DEVELOPMENT APPLICATION ASSESSMENT REPORT

Application Number:	DA2024/1401
----------------------------	-------------

Responsible Officer:	Jordan Howard
Land to be developed (Address):	Lot 12 DP 25959, 3 Lalchere Street CURL CURL NSW 2096
Proposed Development:	Alterations and additions to a dwelling house
Zoning:	Warringah LEP2011 - Land zoned R2 Low Density Residential
Development Permissible:	Yes
Existing Use Rights:	No
Consent Authority:	Northern Beaches Council
Land and Environment Court Action:	No
Applicant:	John Stanley Frize

Figure 1 - Extract of South Elevation with side boundary envelope encroachment in red.

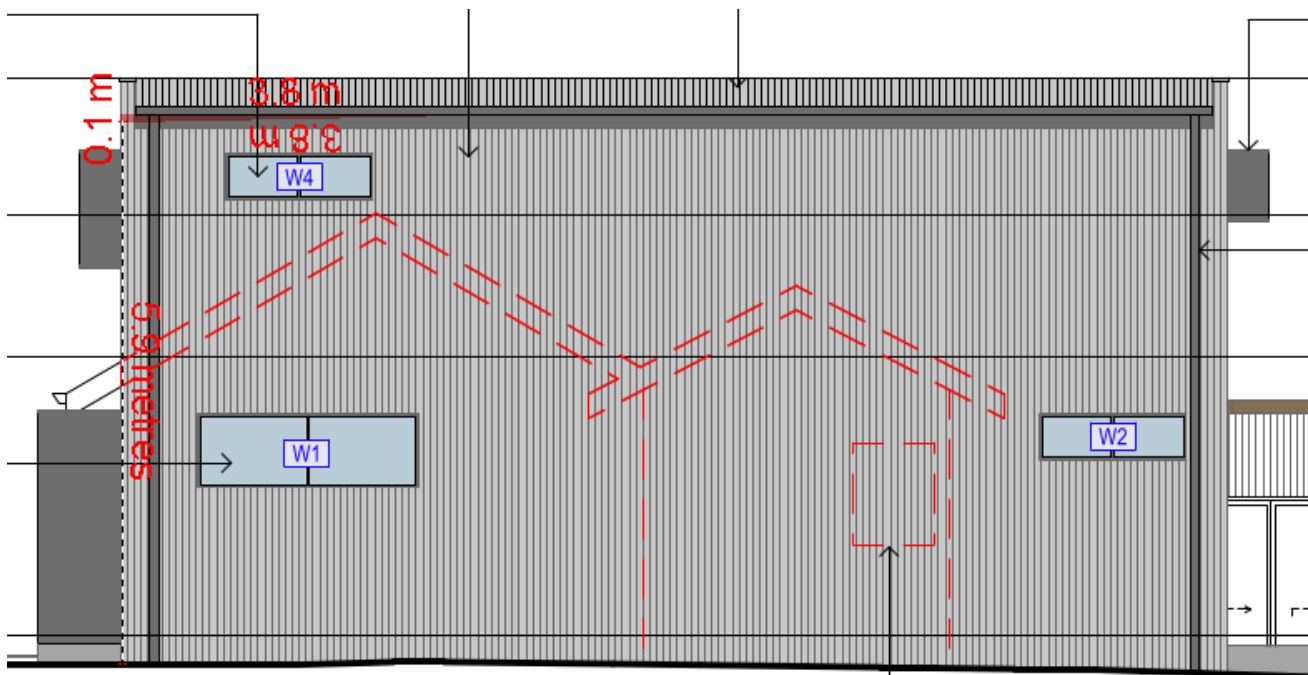
Description of non-compliance

Under this Clause, buildings must be sited within a building envelope determined by projecting planes at 45 degrees from a height of 5m above ground level (existing) at the side boundaries.

The proposed development exhibits a very minor encroachment of the side building envelope on the southern elevation as depicted in *Figure 1*. The encroachment is 0.1m in vertical height and 3.8m in horizontal length.

The proposed development is compliant with the building envelope control at the northern elevation.

The proposed development is compliant with the maximum height of buildings development standard and side setback built form controls. The breach is considered to be very minor and to not result in a development that is visually dominant by virtue of its height and bulk.

Furthermore, it is noted that the subject site is adjoined to the south by a mixed use development which exhibits a large solid wall (approx. 5m high) on the side boundary. The proposed development would be less visually dominate than this neighbouring property.

The proposed development is not considered to result in any unreasonable amenity impacts on adjoining properties (including light, solar or privacy impacts) and is considered to provide adequate spatial separation between buildings. Again, the breach is considered to be very minor.

The proposed development is consistent (or smaller) than surrounding development on similar topography, and remains within the maximum height of buildings development standard. Therefore, the proposal is considered to ensure that development responds appropriately to the topography of the site. Again, the breach is considered to be very minor.

Having regard to the above assessment, it is concluded that the proposed development is consistent with the relevant objectives of WDCP and the objectives specified in s1.3 of the Environmental Planning and Assessment Act, 1979. Accordingly, this assessment finds that the proposal is supported, in this particular circumstance.
